Location Address: 2231 FILLMORE ST and 2224 PIERCE ST, HOLLYWOOD FL 33020

Explanation of Request: NEW CONSTRUCTION, 63 UNIT, RENTAL APARTMENT BUILDING

**SUBJECT:** Preliminary Site Plan review for a 63 Unit residential development.

# FILLMORE STREET APARTMENTS

**WATER & SEWER CONNECTION PLAN**  
SCALE: 1"=20'

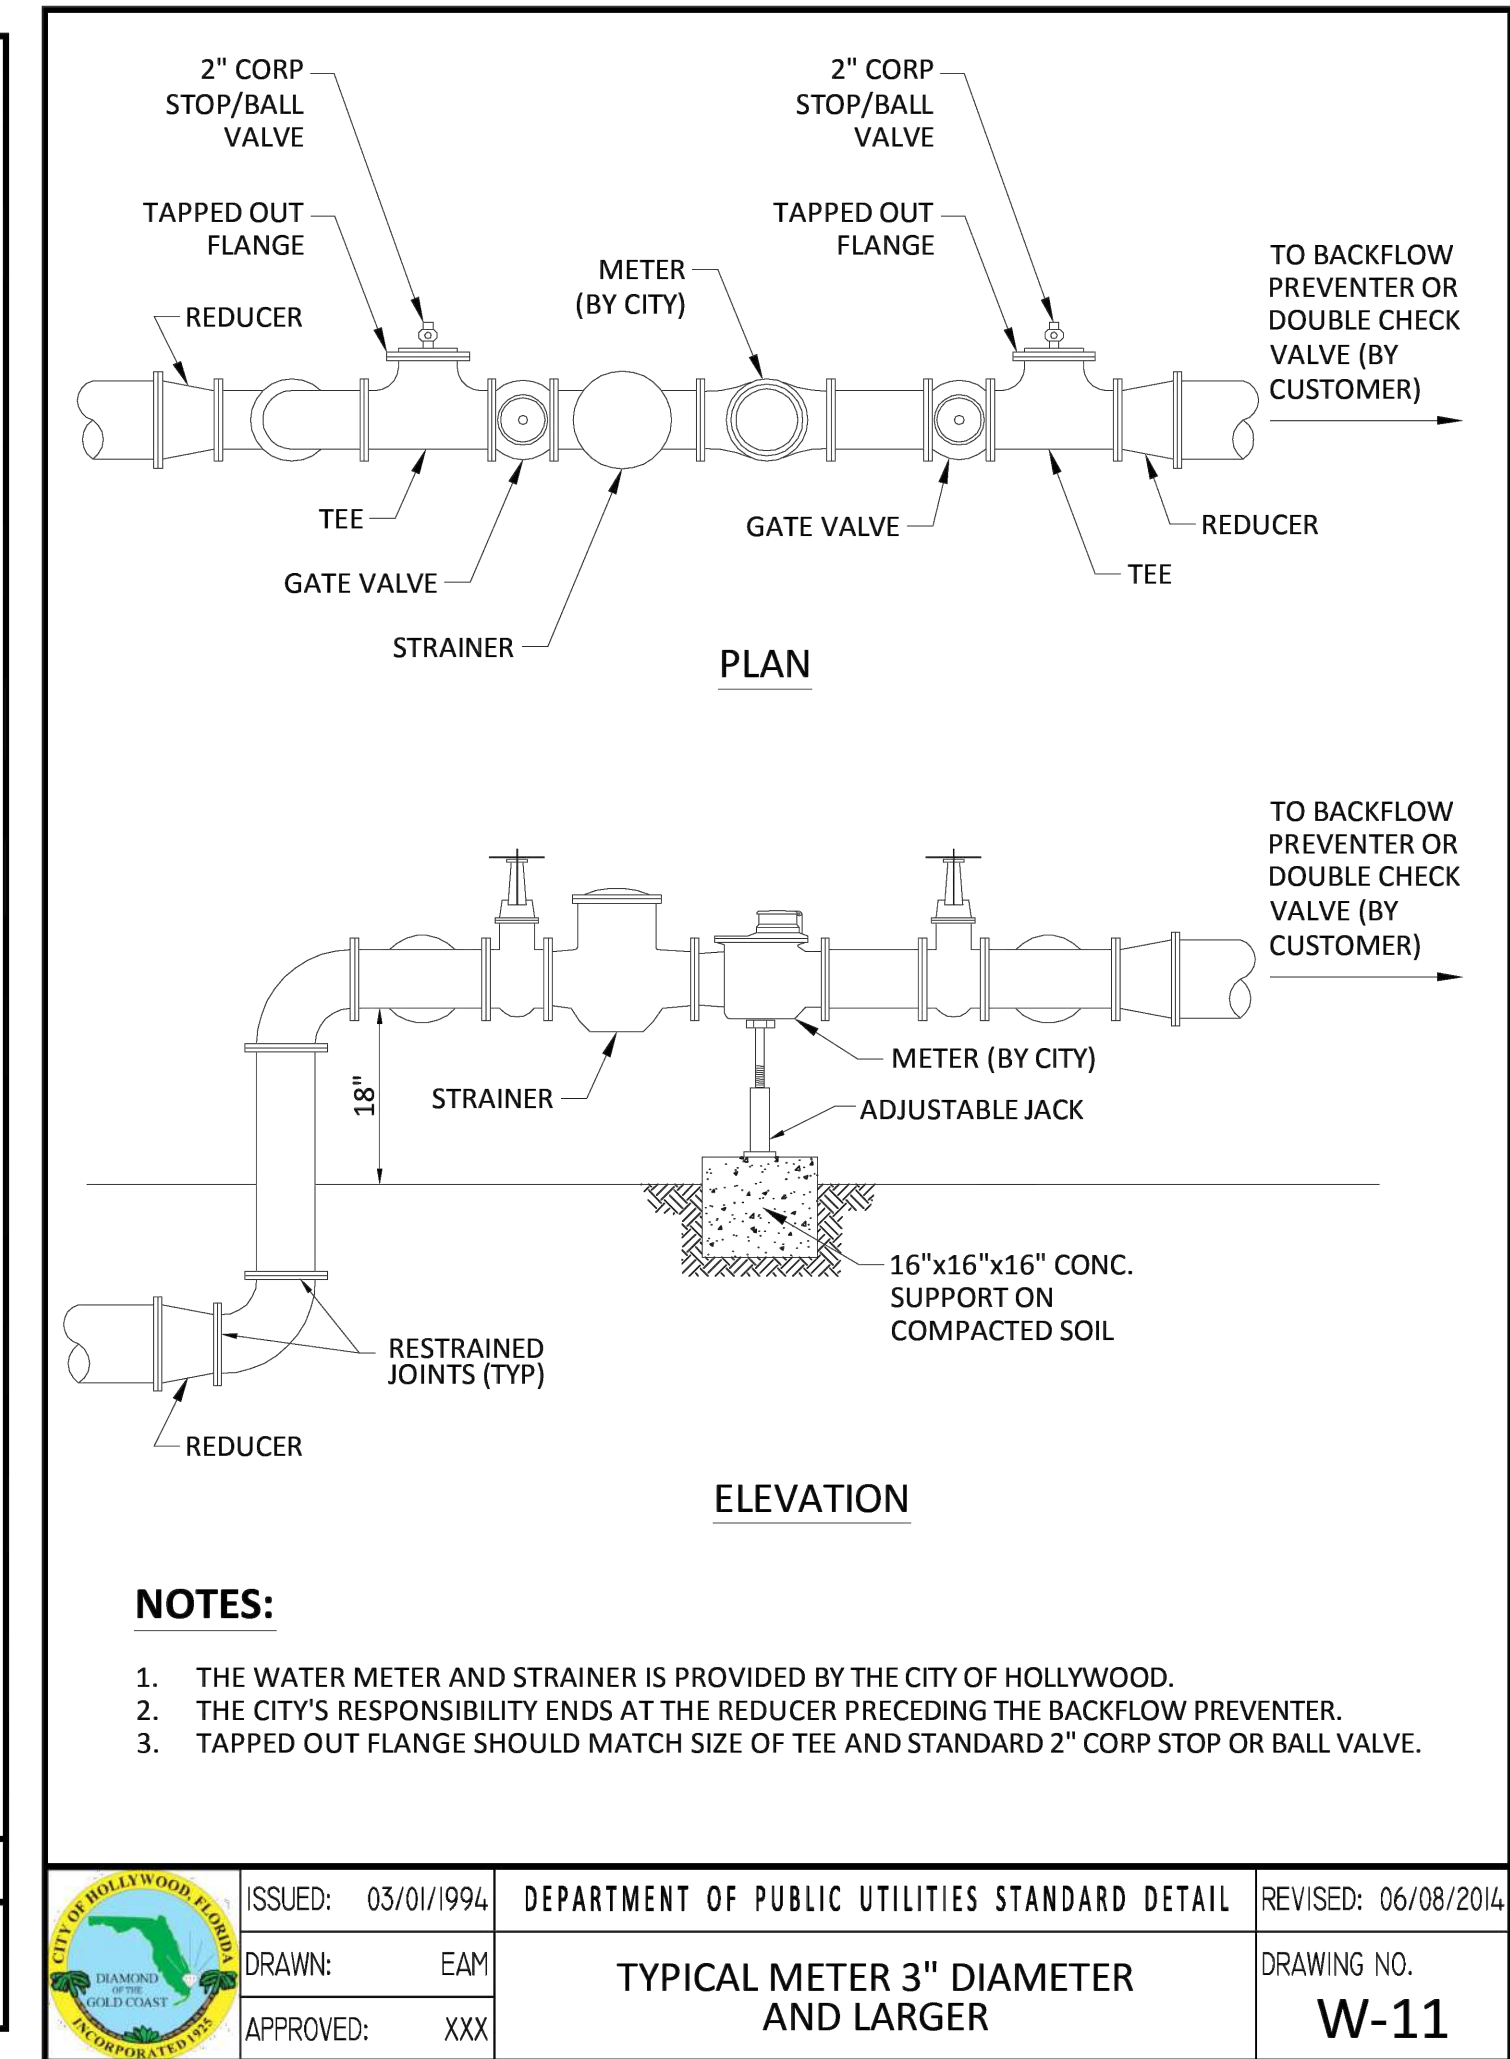
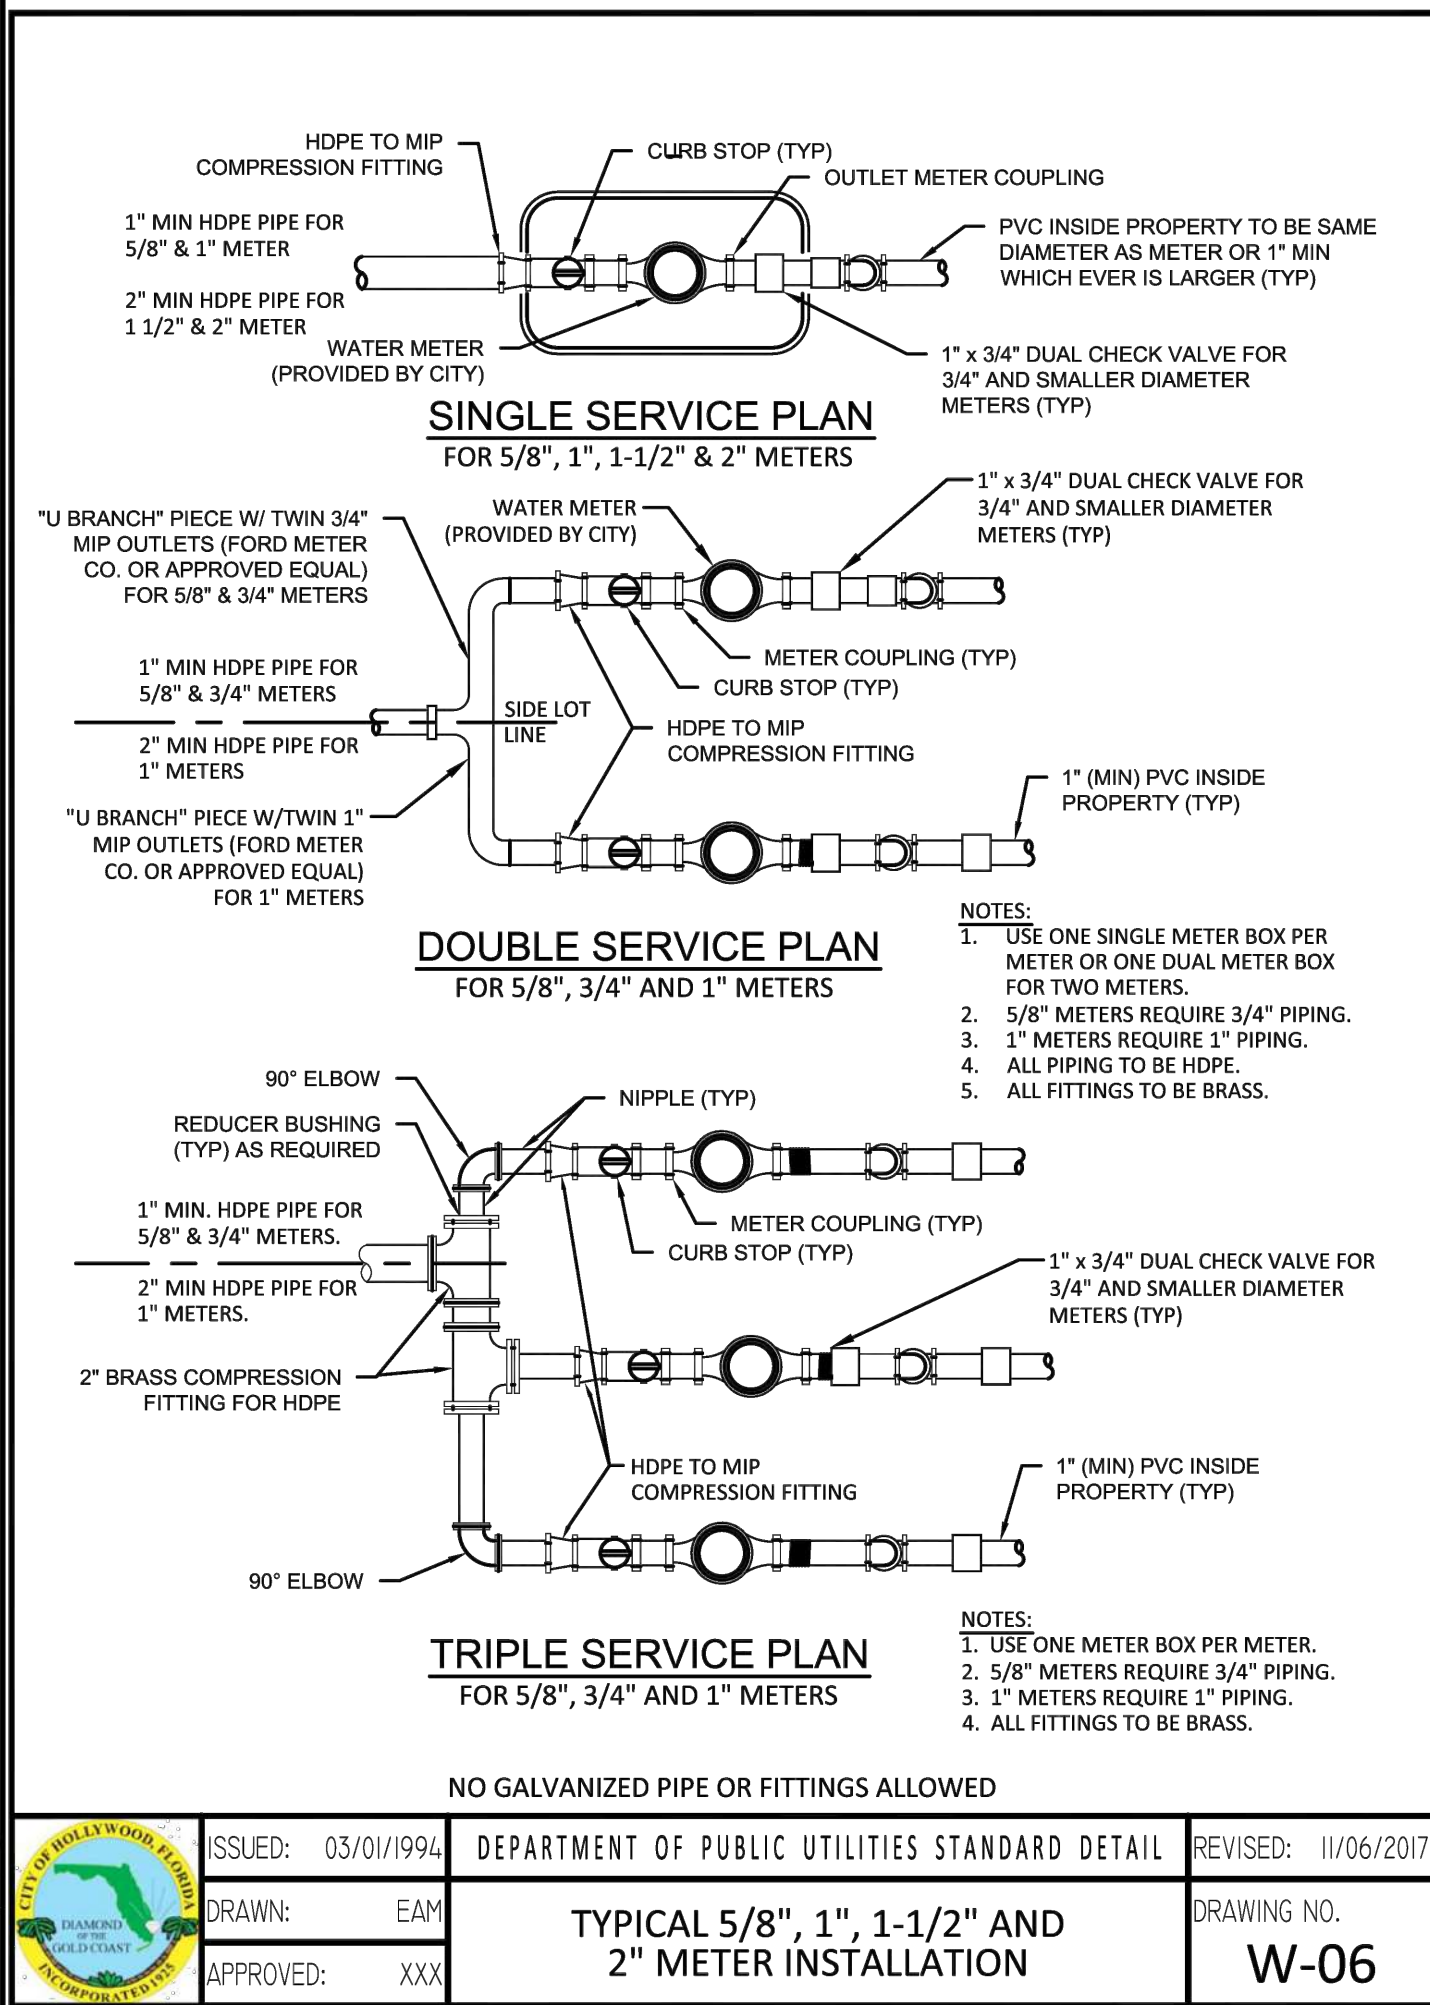
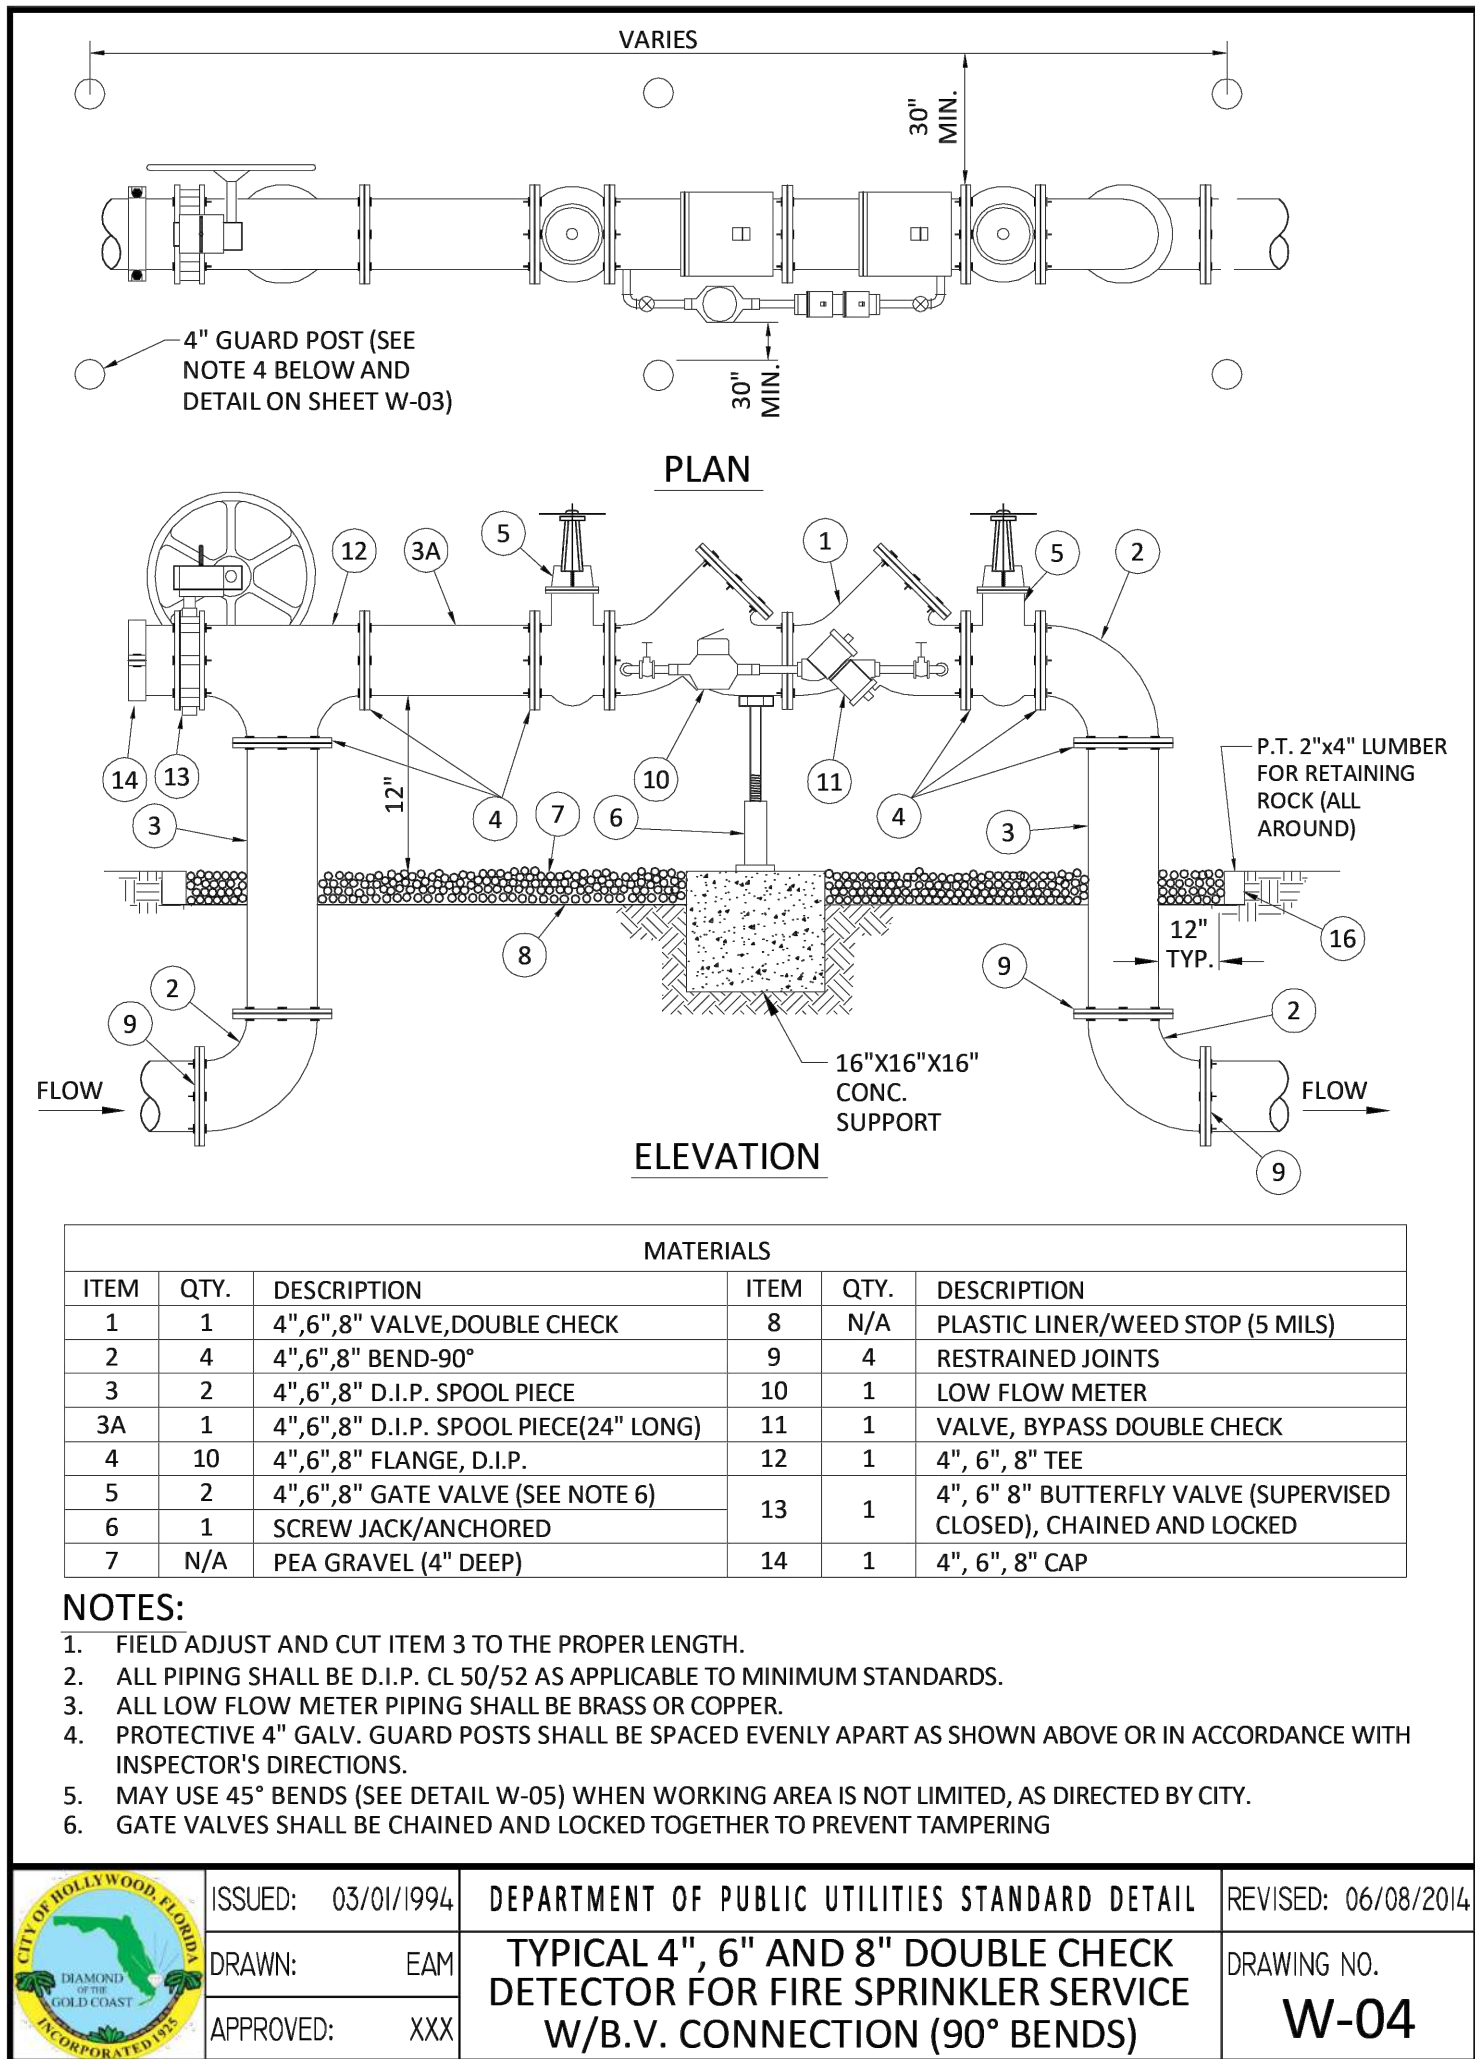
2. Show water and sewer demand calculations on proposed utilities plans.  
**RESPONSE: Please see sheet C8.**
3. Clarify how the water, fire and sewer will be serviced for this property.

**RESPONSE: Please see sheets C7 & C8.**
4. Include the City's latest applicable standard water and sewer details. The details are available on the City's website via the following link: <http://www.hollywoodfl.org/1169/Standard-Details-and-Public-Notices> .

**RESPONSE: Please see note on sheet C8.**
18. Provide civil drawings for the underground fire main. --- Provide such including the location of the fire

department connection, DDCV, and size of the fire line from the water supply. --- Check with our water department for city requirements in addition to fire. --- Ensure on the plans that there is a fire hydrant within 100 feet of fire department connections.

**RESPONSE: Please see sheet C8.**
